**PORT PHILLIP BAY
CHANNEL DEEPENING
ENVIRONMENT EFFECTS STATEMENT
VOLUME 1**

PANEL REPORT

11 February 2005

Figure 9: Panel Emergency Response Planning Framework Summary

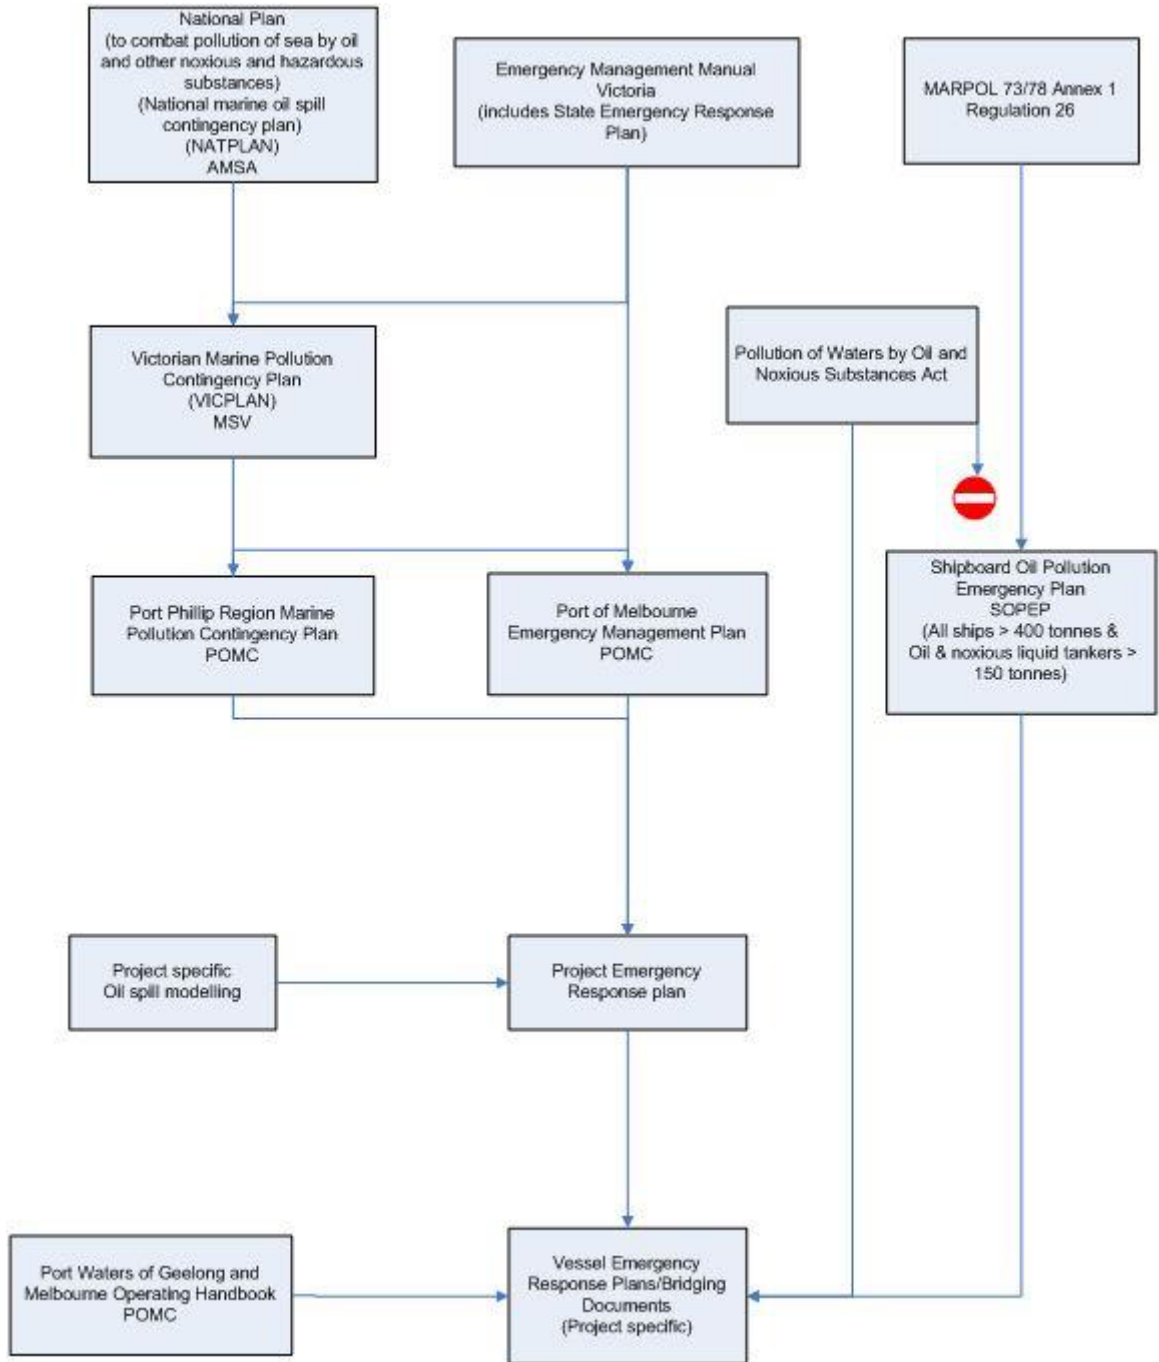
The Panel recommends:

At a project level there needs to be a hierarchy of project and vessel specific emergency response plans that are well integrated. Work needs to be done to identify any additional response equipment required as a result of the project and all persons require training at an appropriate level in the implementation of the plans. All plans need to be bridged (linked) to other relevant documents.
